Docket 50-305  
Operating License DPR-43  
Kewaunee Nuclear Power Plant  
Response to NRC Request For Additional Information Concerning Leak  
Before Break Analysis For Kewaunee Nuclear Power Plant

**Nuclear Management Company, LLC Response to NRC's Request for Additional Information Regarding Request to Exclude Dynamic Effects Associated with Postulated Pipe Ruptures From Licensing Basis for Residual Heat Removal, Accumulator Injection, and Safety Injection System Piping Based Upon Leak Before Break Analysis.**

**Leak-Before-Break Evaluation  
6-inch to 12-inch Safety Injection and  
Residual Heat Removal Piping Attached to the RCS  
Kewaunee Nuclear Power Plant  
Revision No. 1**

Designed by  
**FLUOR ENGINEERS, INC.**  
 CHICAGO, ILL. 60606

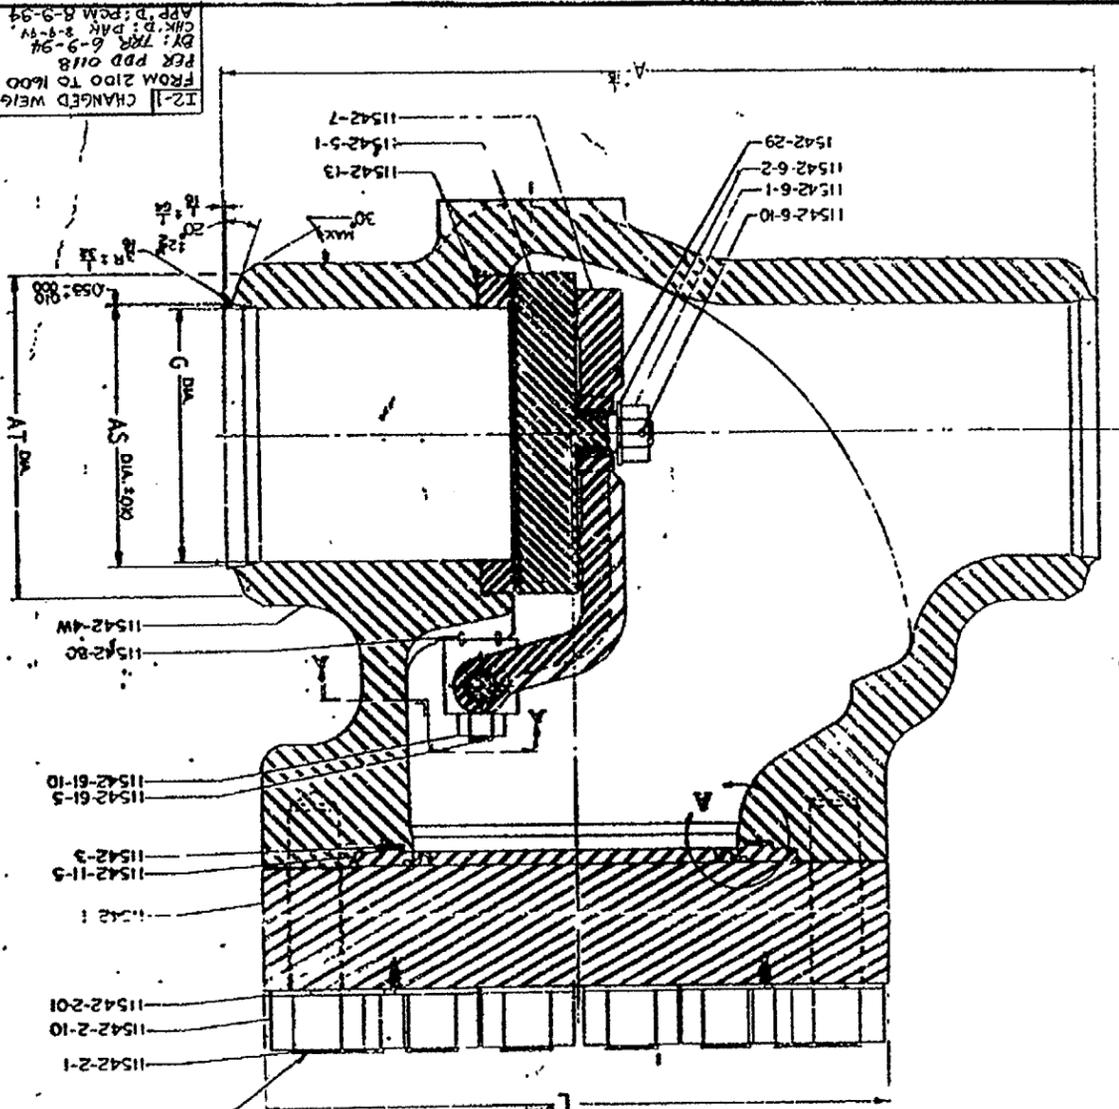
**NRC Question #1.** The cover letter to NMC's February 23, 2001, submittal states that NMC is requesting Leak-Before-Break approval for the following piping at the Kewaunee Nuclear Power Plant (KNPP), along with some description of each item:

- (1) 12-inch diameter safety injection system piping;
- (2) 8-inch diameter residual heat removal system piping;
- (3) 6-inch diameter cold leg safety injection system piping;
- (4) 6-inch diameter reactor vessel safety injection system piping.

Confirm whether or not item (4) is actually included in the KNPP submittal inasmuch as no specific tabular information in the report was identified as applying to the 6-inch diameter reactor vessel safety injection system piping. Provide piping diagrams (similar to those shown in Figures 5-7, 5-8, and 5-9 of report SIR-00-045, Rev. 0), which show the specific portions of the KNPP piping systems for which LBB approval being sought.

Tables 4-3, 4-4 and 4-5 do represent the nodal moments specific to the KNPP systems in question. For the 6-inch hot leg nozzle, there are no moments since the nozzle is capped.

There are no cast austenitic steel piping sections present in any of the analyzed portions of piping. However, two valves (SI-22A and SI-22B) that function to isolate reactor coolant fluid are fabricated from CF-8 material. These valves are part of the 12-inch diameter safety injection system piping identified under item 1 in NRC question 1. A drawing for these valves is provided in attachment 2. Since the valves are much thicker than the attachment piping and pipe-to-valve weldments, standard practice in LBB evaluations has been not to include these relatively thicker components in the LBB evaluation.

Figure 5-7. Schematic of Piping Layout Used to Determine the Effect of Restraint on LBB Evaluation (8-inch RHR Line – Prairie Island Unit 1, Loop A)

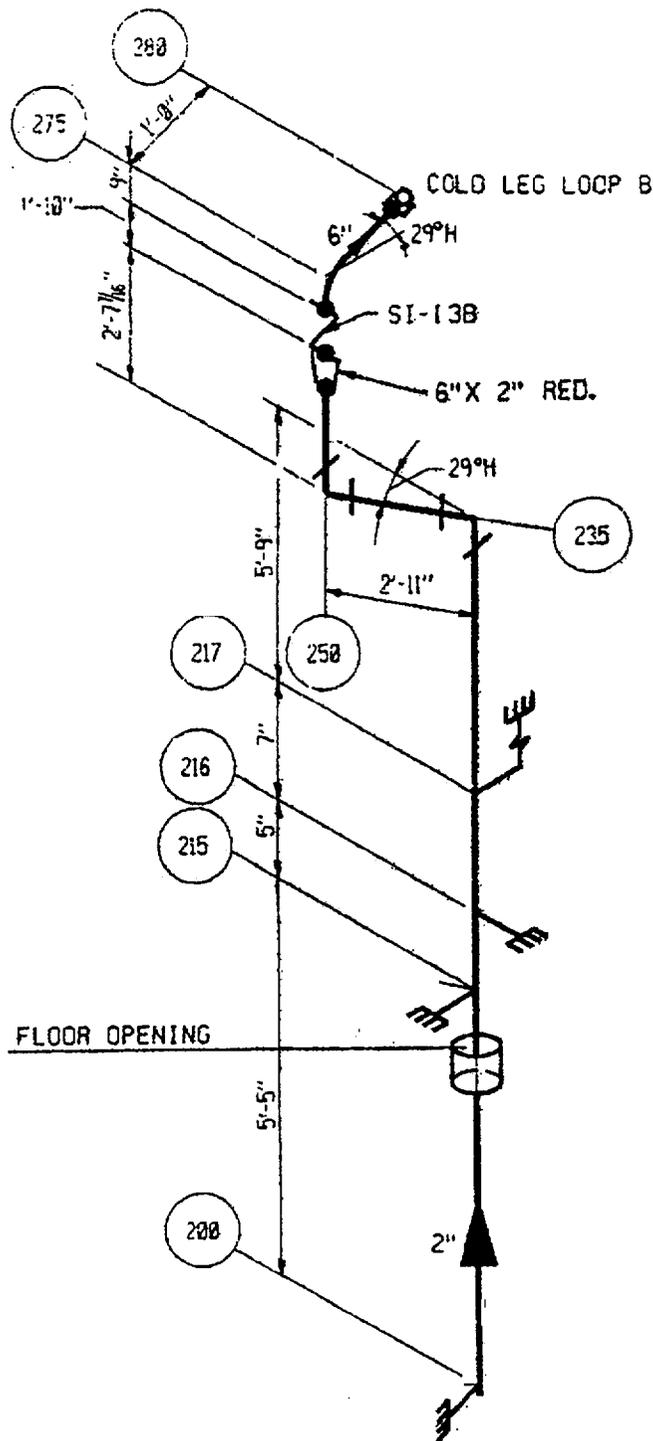
**NRC Question #7:** It is stated on page 5-10 of SIR-00-045, Rev. 0 that, “[t]he evaluation consists of first modeling the piping lines and then applying a kink angle at all weld locations from the LBB analysis. The process resulted in applied moments at each weld location that could be used in assessing leakage rate reduction. The three selected piping lines were modeled as PIPE16 elements using the ANSYS computer code [22]. All three models were bounded by two anchors, one of them being the connection to the RCS system. The other was placed at a significant distance away from the welds of interest.”

The piping systems considered in the analysis were all relatively flexible piping modified systems. To minimize the cost associated with the analysis, the piping systems between the RCS nozzles and the end anchor points was not all included in the models. Instead, a point on the piping system closer to the RCS nozzle, but far enough away to provide sufficient flexibility was chosen based on engineering judgment. In choosing this assumed anchor location, the modeled piping system would be stiffer than that which actually exists in the field, and would produce higher moments due to restraint than would actually exist in the field. Figures 5-7 to 5-9 from the report included herein, have been modified to indicate the locations of the assumed anchor points.
